TECHNICAL INFORMATION ZM497 AND ZM1497

NEW SUITABILITY WITH VALEO 594449 AND ADAPTABLE TO STARTERS D6RA110

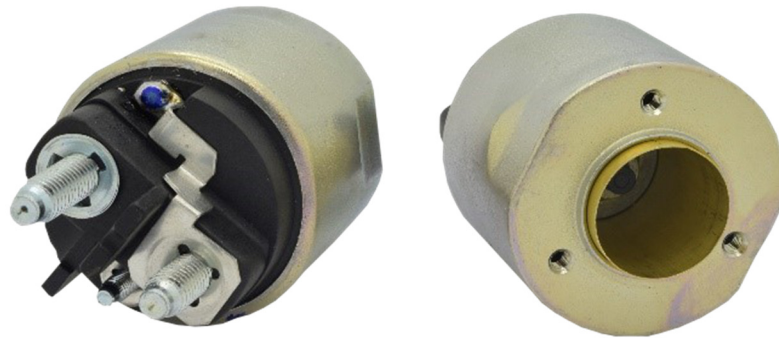
Our Supplier ZM, during range improvement, has changed the solenoid [ZM497](#) drawing.

The most visible change (red circles) is the double facet on the body in order to get easy the placement on the specific starter bracket.

The main goal was enlarge the application list to starter Valeo [D6RA110](#), without open new project.
